ORIGINATION FORM

Proposed Revisions to a Standard Plans Index
(Please provide all information — Incomplete forms will be returned)

Index Number: 102-607
Sheet Number (s): 1
Index Title: Mobile Operations

| LAST REVISION | 11/01/20 | DESCRIPTION: | | FY 2021-22 STANDARD PLANS | MOBILE OPERATIONS | INDEX 102-607 | SHEET 1 of 2 |

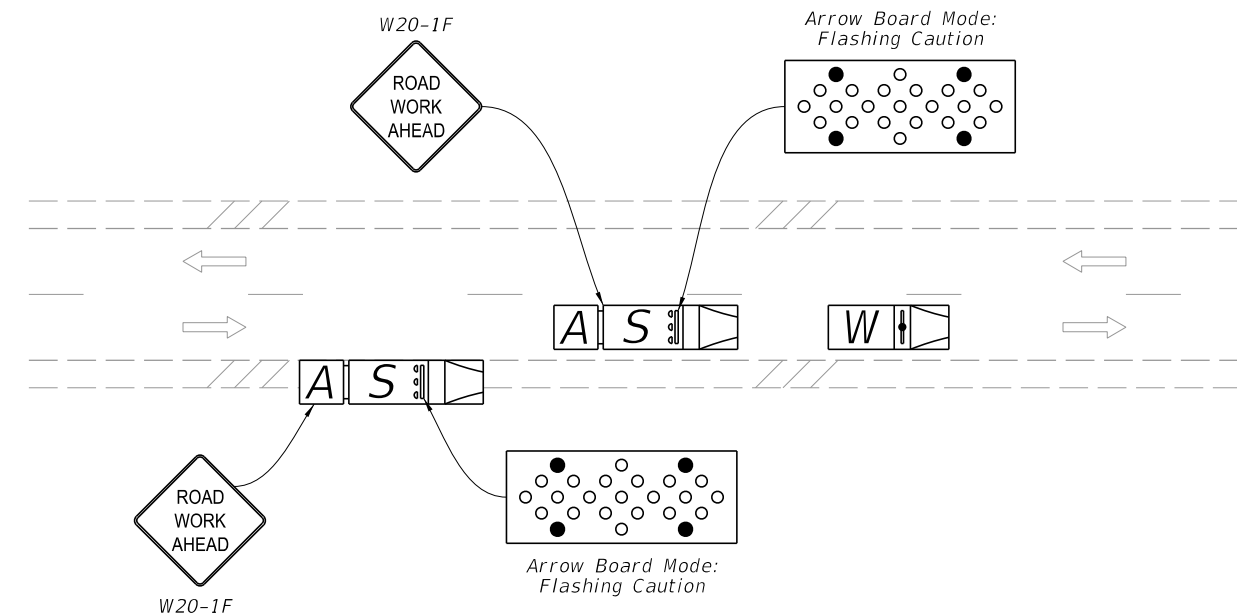
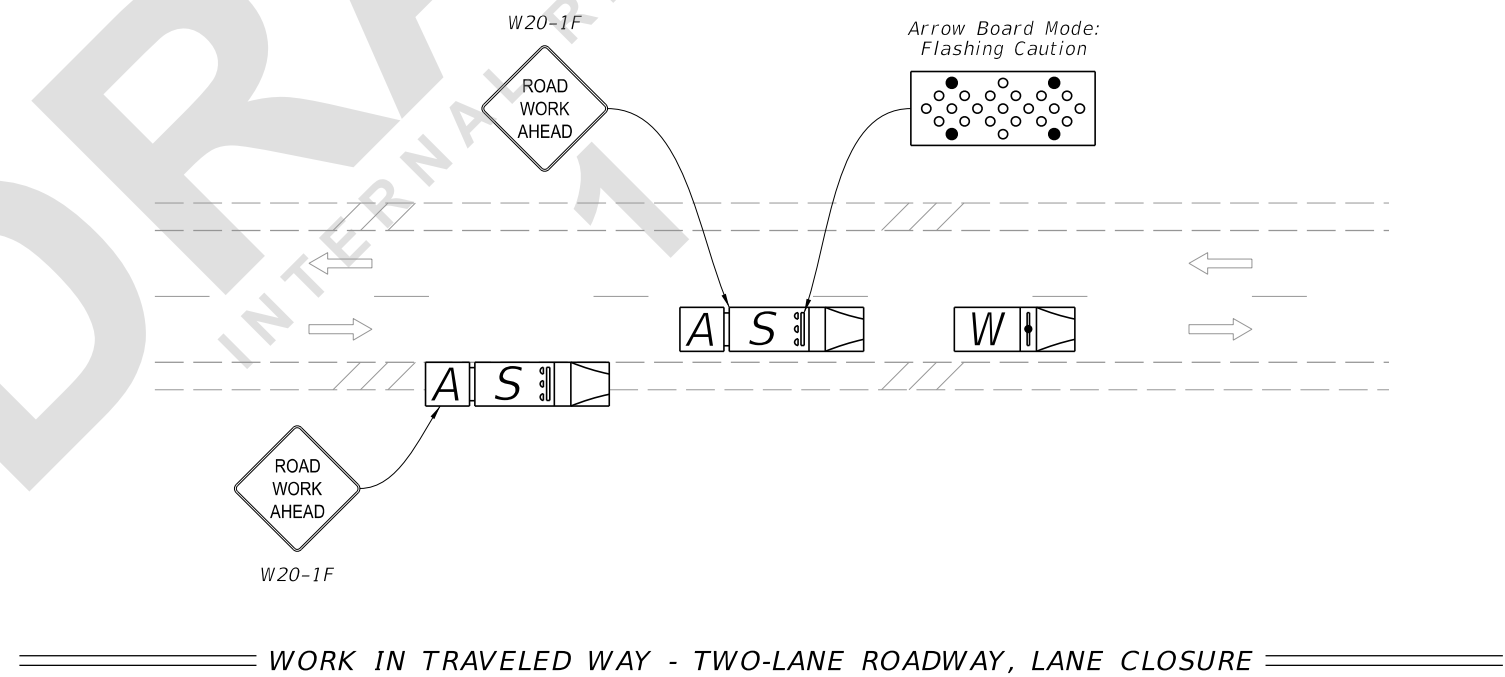
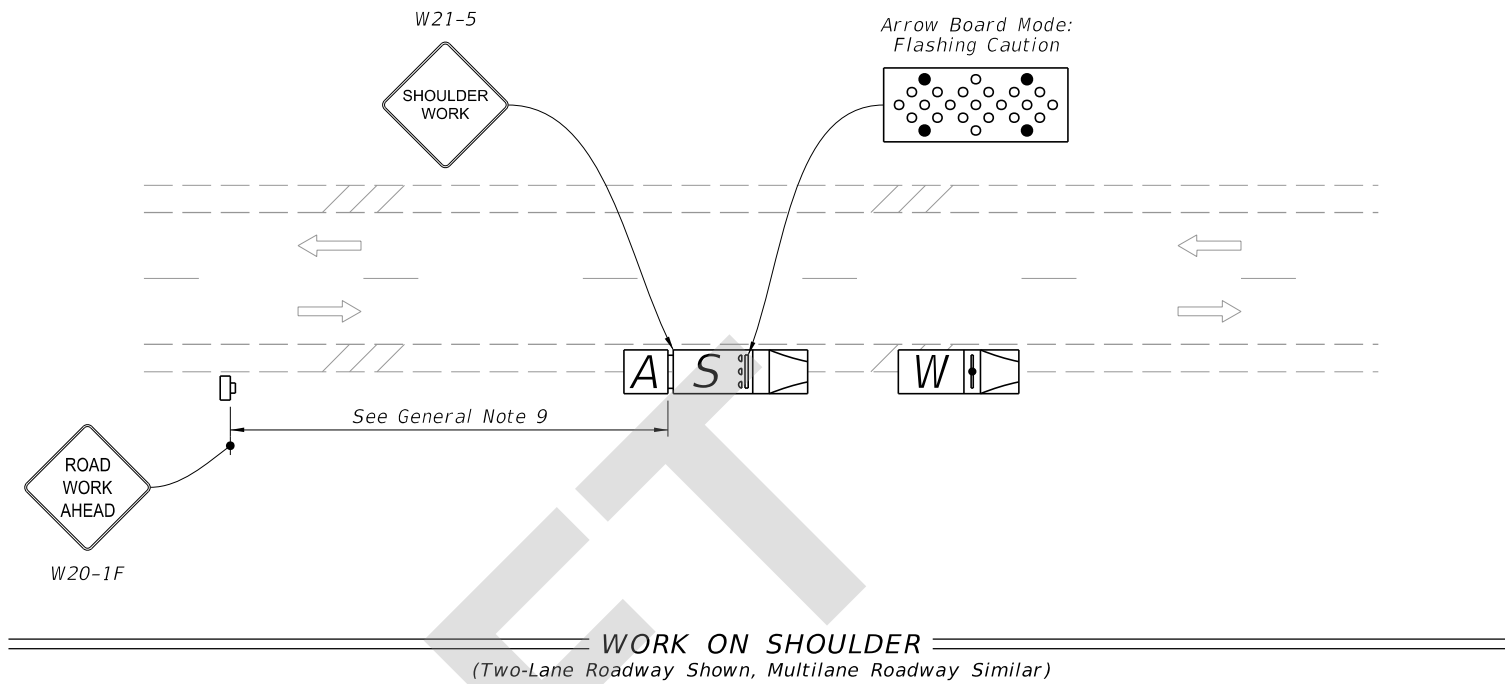
Sheet1: Changed General Note 4 to: Where work activities within 2' of the edge of traveled way are incidental (i.e., Mowing, Litter Removal), the Engineer may omit requirements for signs and the Shadow vehicle on the shoulder.

Delete the last part of Note 4 due to redundancy with Spec 102 that requires vehicles in the work area to have operating high-intensity rotating, flashing, oscillating, or strobe lights. Changed "delete" to "omit" in Note 4 to be consistence with the language in 102-602 Note 3.

4. ~~Where work activities within 2' of the edge of travel way are incidental (i.e., Mowing, Litter Removal), the Engineer may delete requirements for signs and the Shadow vehicle on the shoulder provided vehicles in the work area have high intensity rotating, flashing, oscillating, or strobe lights operating.~~

CHANGED TO:
 Where work activities within 2' of the edge of traveled way are incidental (i.e., Mowing, Litter Removal), the Engineer may omit requirements for signs and the Shadow vehicle on the shoulder.

4. Where work activities within 2' of the edge of travel way are incidental (i.e., Mowing, Litter Removal), the Engineer may omit requirements for signs and the Shadow vehicle on the shoulder.
